**Tillbridge Solar Project
EN010142**

**Applicant's Response to Examining Authority's
First Written Questions**
Document Reference: EN010142/APP/9.27

**December 2024
Revision Number: 00**

FIGURE TITLE
Figure in response to ExQ1.1.2 showing where the Order limits for the Tillbridge Solar Project overlaps with the consented Gate Burton Energy Park and Cottam Solar Project.
FIGURE NUMBER
Figure ExQ1.1.2c

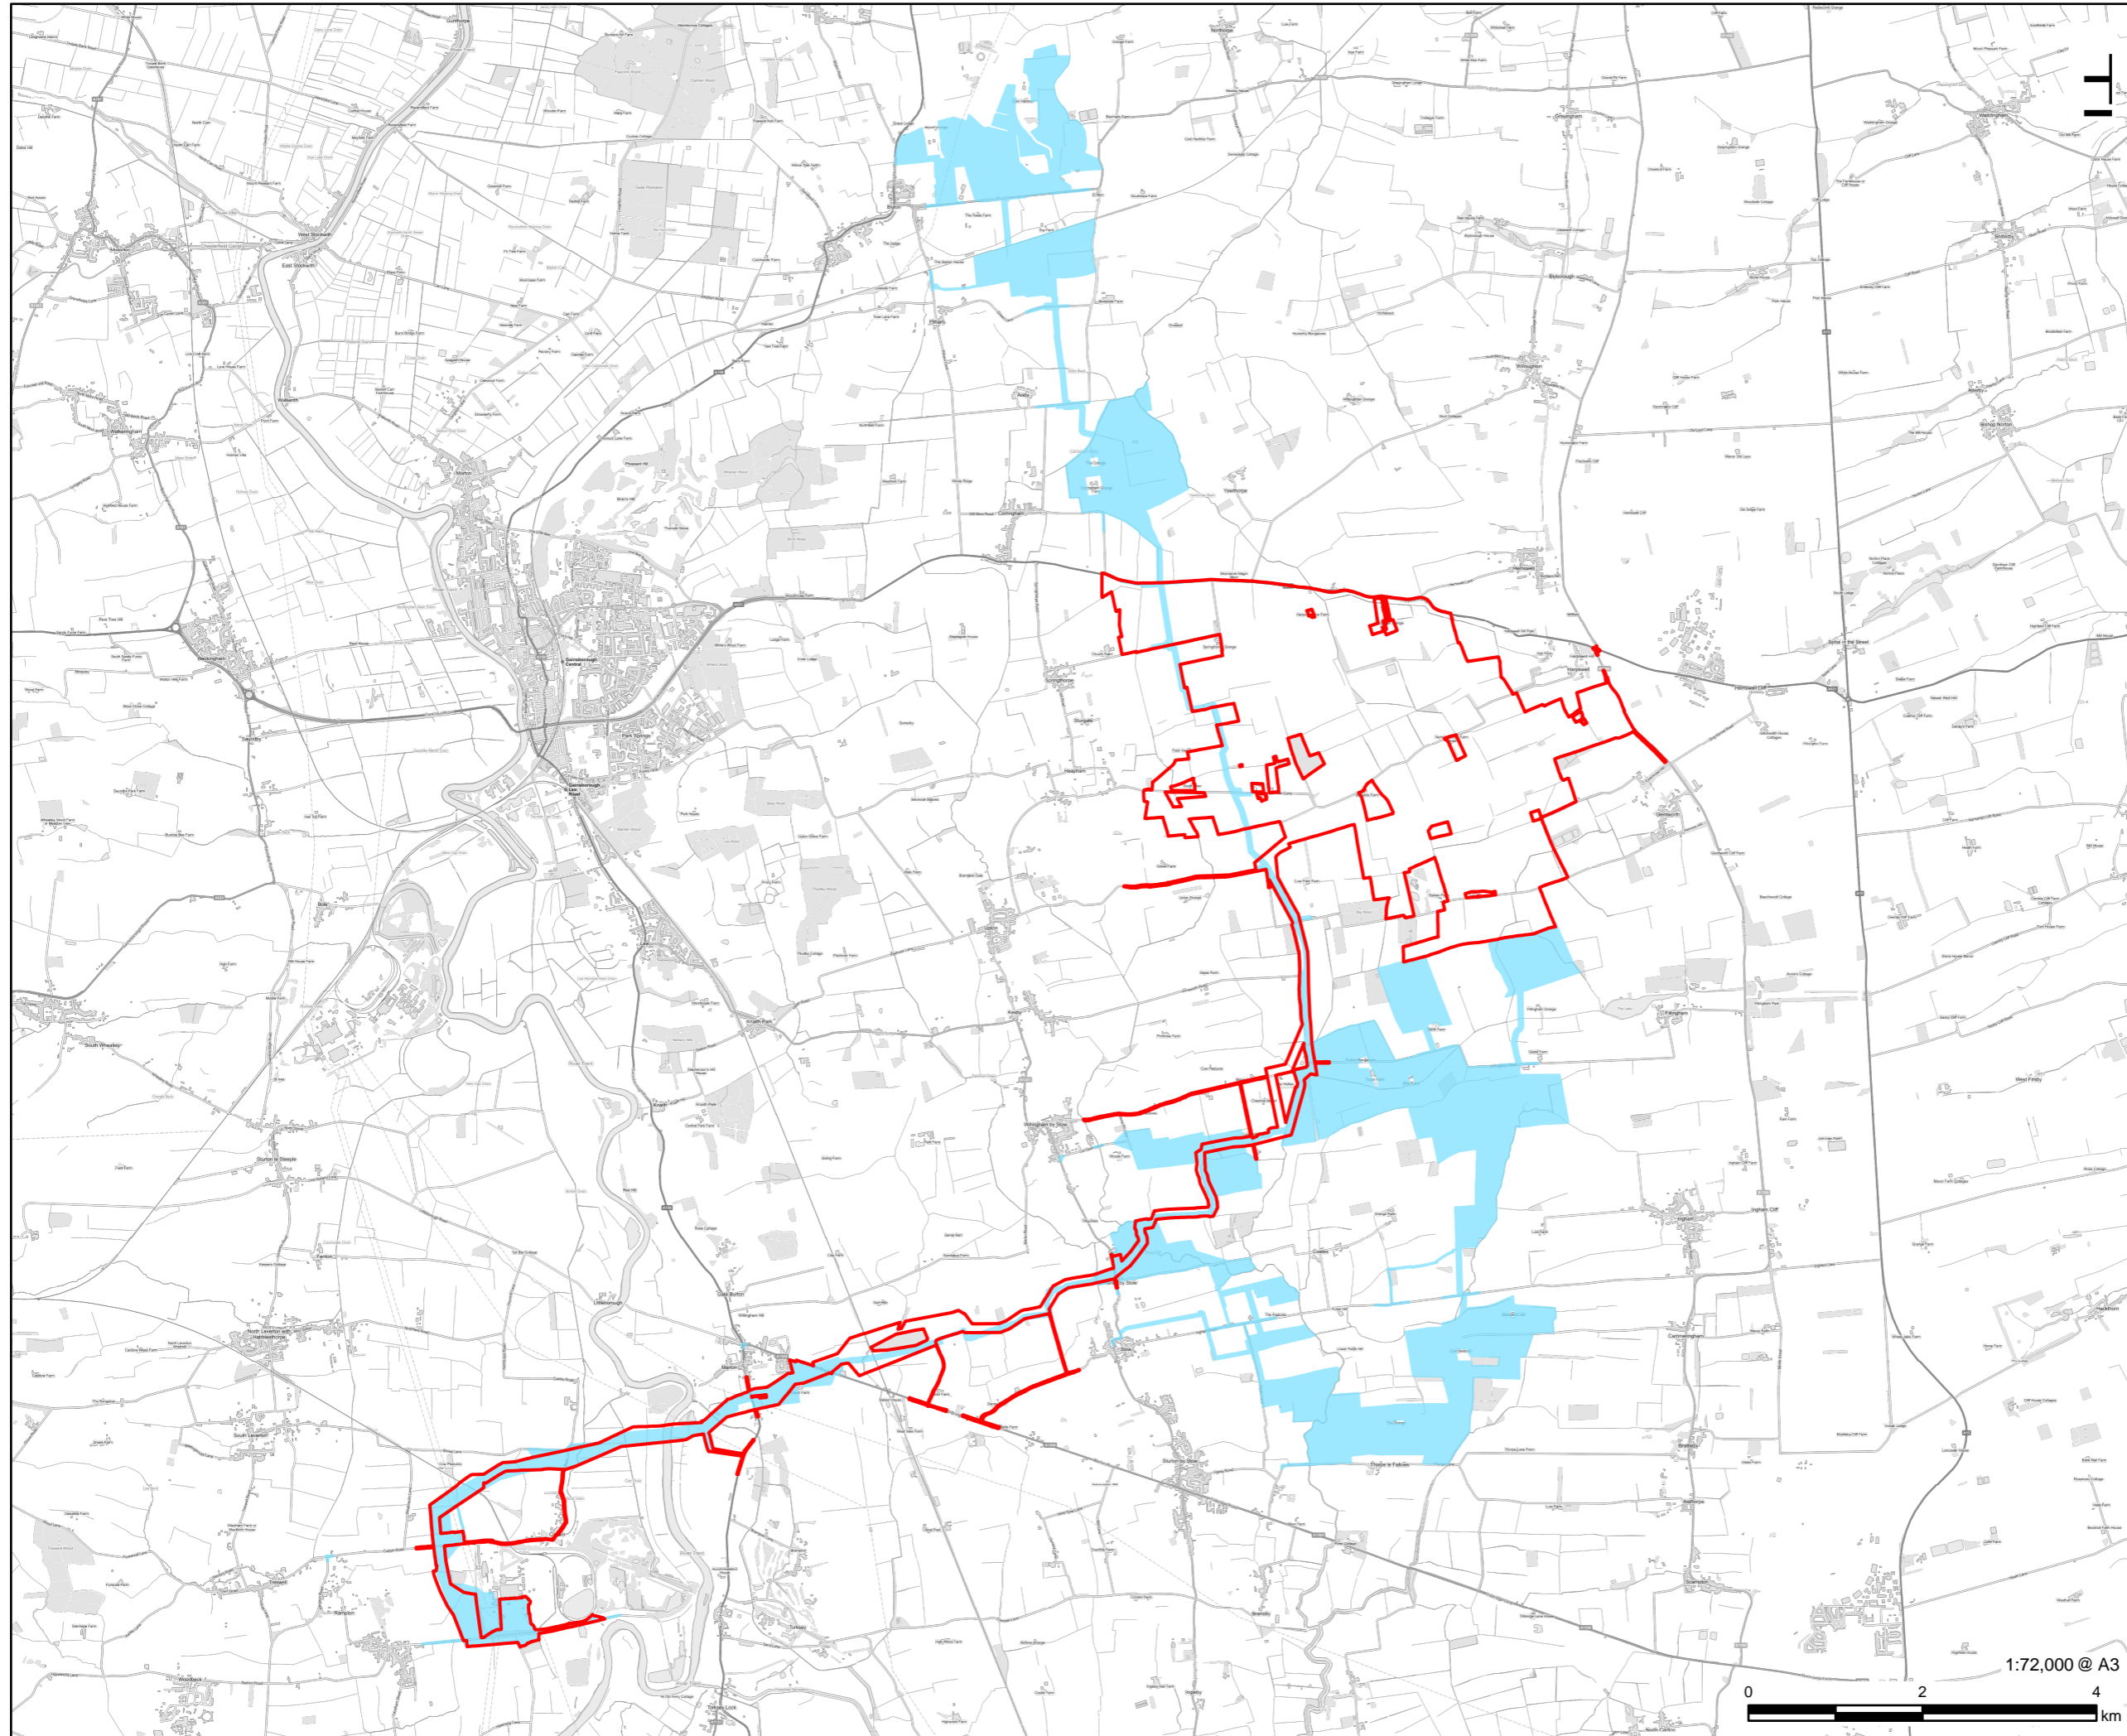
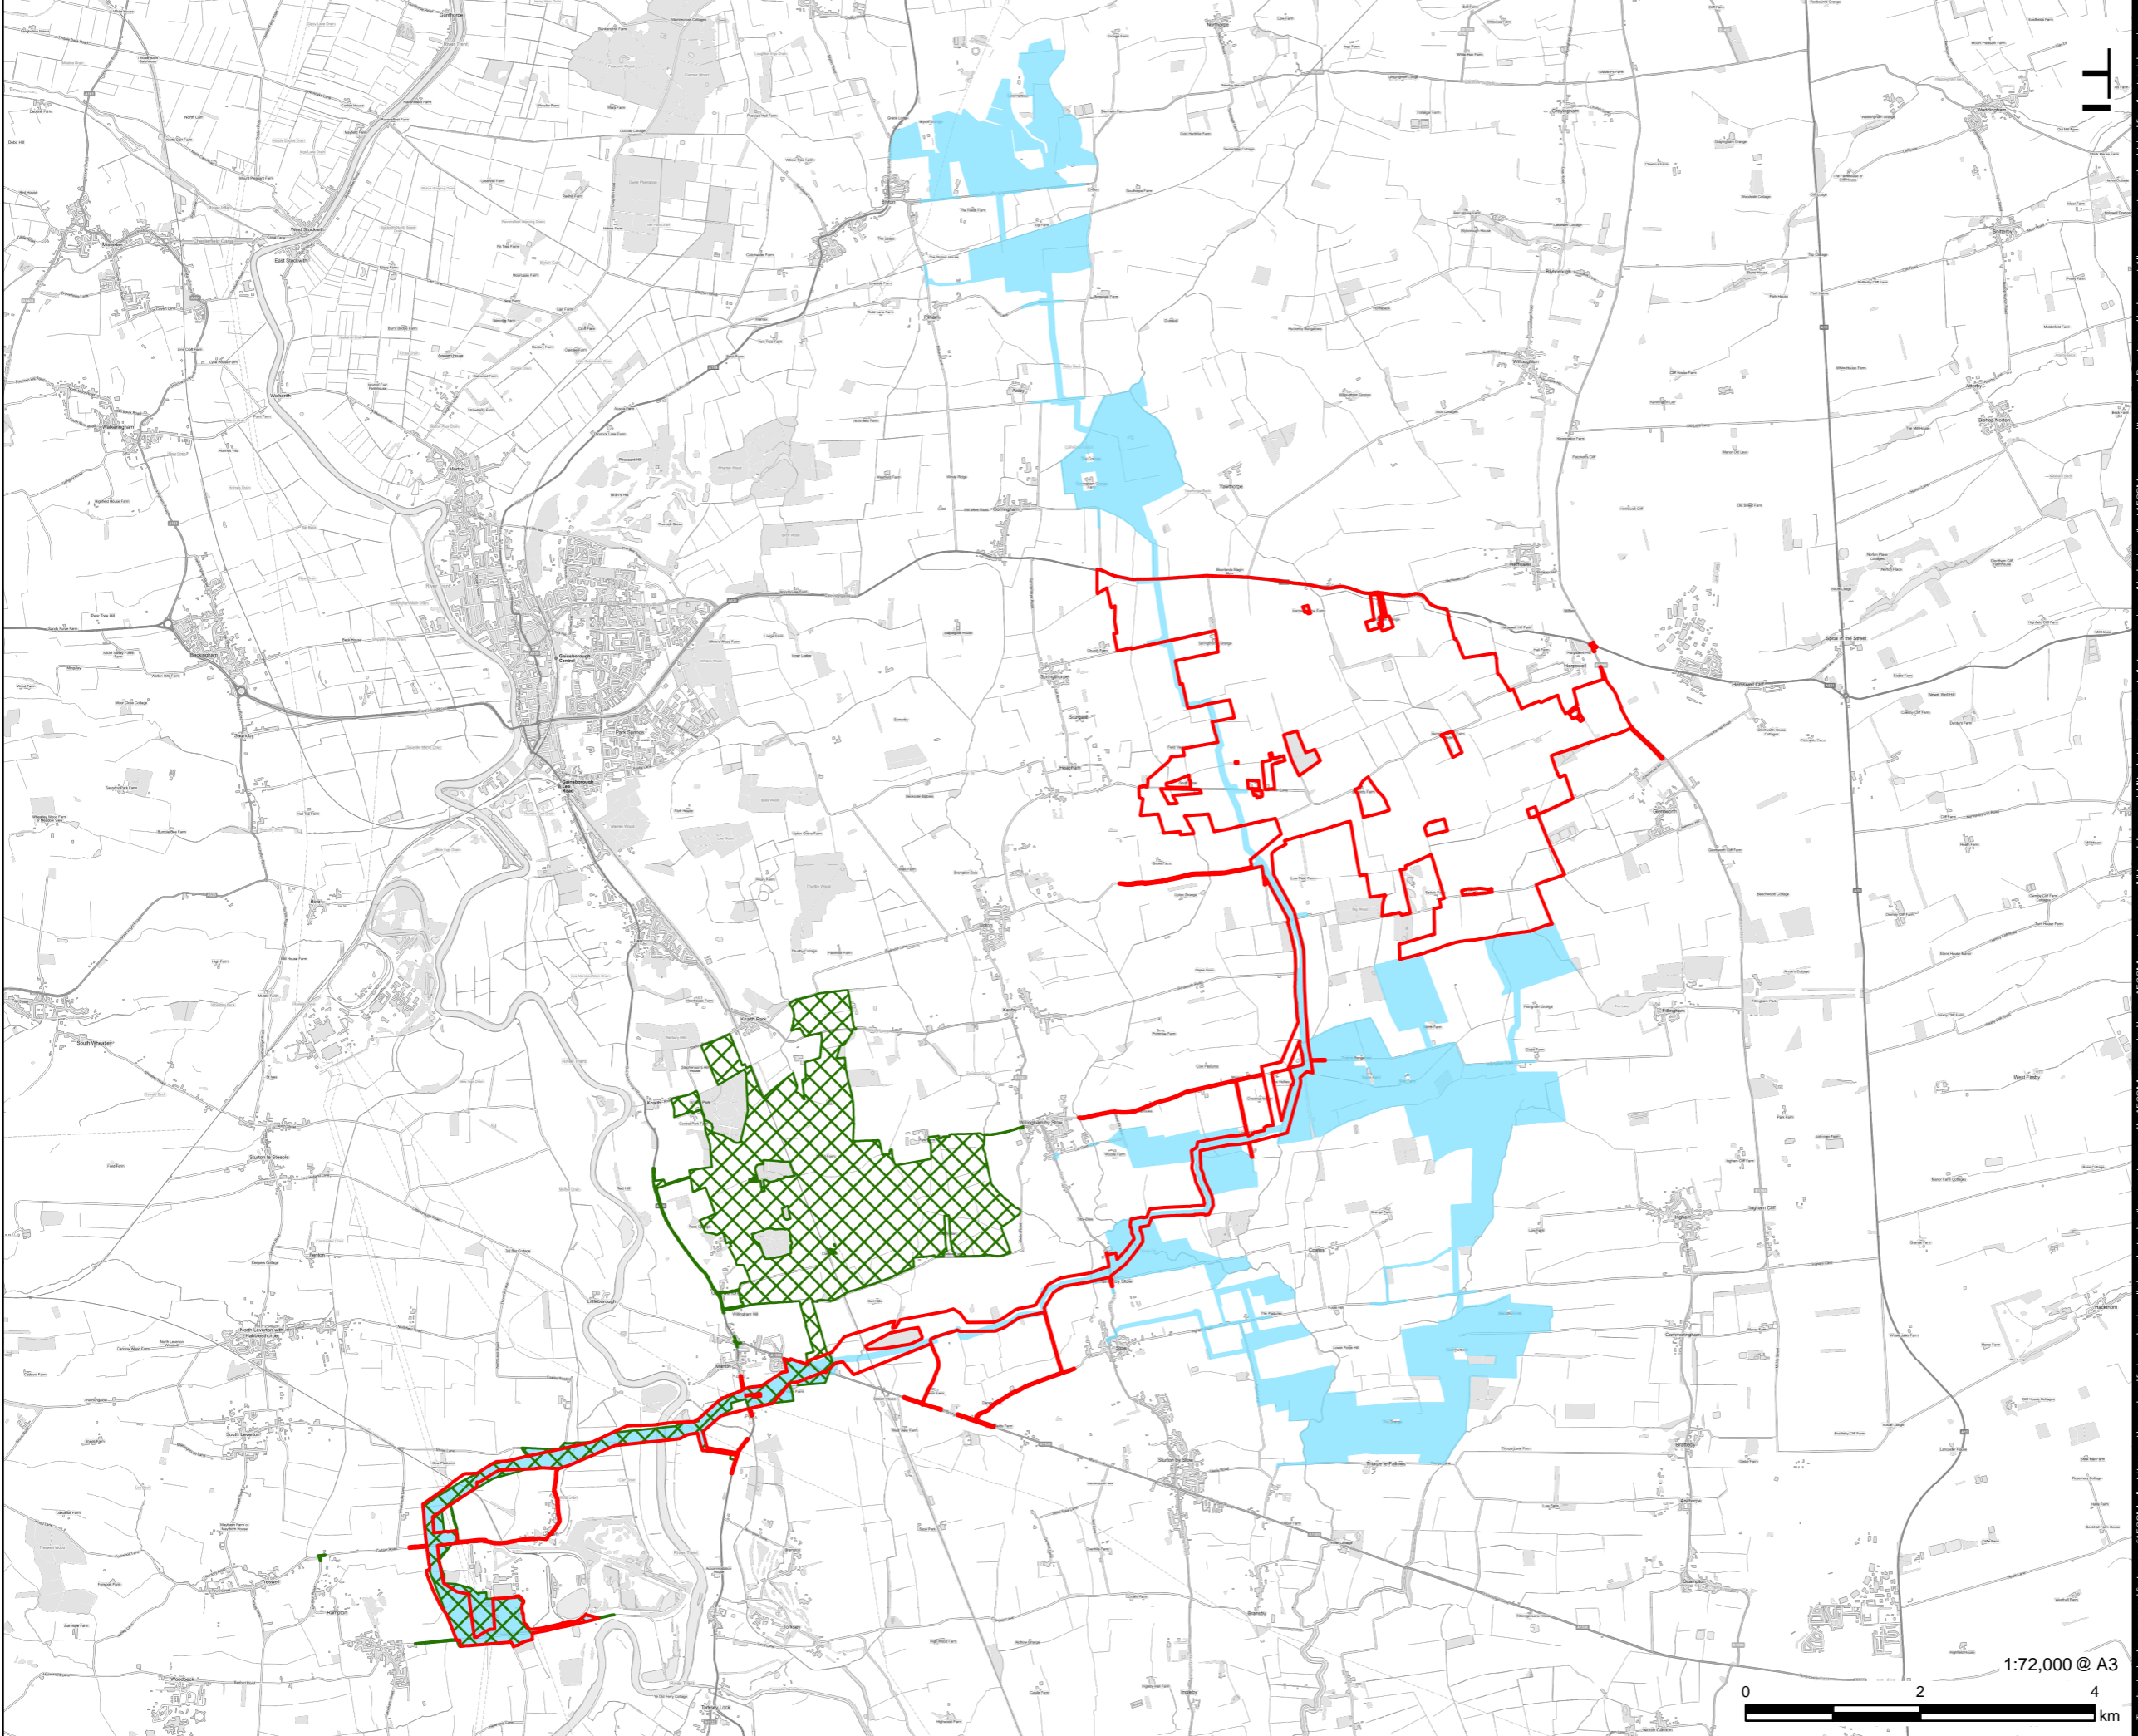
Q1.1.2	Applicant	<p>Commonality with other NSIPs</p> <p>Could the Applicant please identify exactly which parts of the cable route, Cottam substation development and any other development are identical to that for which consent has already been obtained in respect of other schemes. In addition, where statutory and interested parties have raised issues with regard to those common elements of the Proposed Development, could the Applicant please set out (in tabulated form) whether those concerns/ effects have already been considered and addressed by the Secretary of State (SoS) or previous ExAs in relation to other schemes.</p>	<p>Appendix A to the Applicant's Response to ExA's First Written Questions [EN010142/APP/9.27] (this document) includes Figures 1a, 1b and 1c which show where the Order limits for the Tillbridge Solar Project overlap with the Gate Burton Energy Park and Cottam Solar Project consented schemes. The areas that overlap fall within the shared cable route and Cottam Substation.</p> <p>In respect of these areas of overlap, the Applicant has agreed protective provisions with Gate Burton Energy Park and Cottam Solar Project, which are included in the draft DCO [EN01010142/APP/3.1(Rev04)]. Equivalent provisions, for the benefit of the Tillbridge Solar Project, have been agreed and included in the made DCOs for Gate Burton Energy Park and Cottam Solar Project.</p> <p>The Applicant has also prepared a table, which can be found at Appendix A of this report which sets out where Statutory Consultees and Interested Parties have raised concerns with regard to the identical areas,</p>

Q1.4.2	Applicant	<p>Cable Route</p> <p>Can the Applicant advise at what stage of the Examination they will have clarity as to the option chosen for the cable route and if it can be confirmed early on to allow focus within the examination to allow affected persons and land to be assessed.</p>	<p>The Applicant has defined the proposed works areas in the Works Plans [REP2-004]. The Applicant is intending to maintain optionality within the Cable Route Corridor of the Works Plans [REP2-004] throughout the Examination, as the confirmation of options to the cable route alignment is subject to detailed design (which will occur post consent, should the Scheme receive consent). It is common practice to allow limited flexibility inside the Order limits at this stage of the project lifecycle with further refinement undertaken at detailed design stage. Similar flexibility has also been allowed for within the Gate Burton Energy Park and Cottam Solar Project Orders (refer to Figure ExQ1.1.2c included within Appendix A of this document).</p>
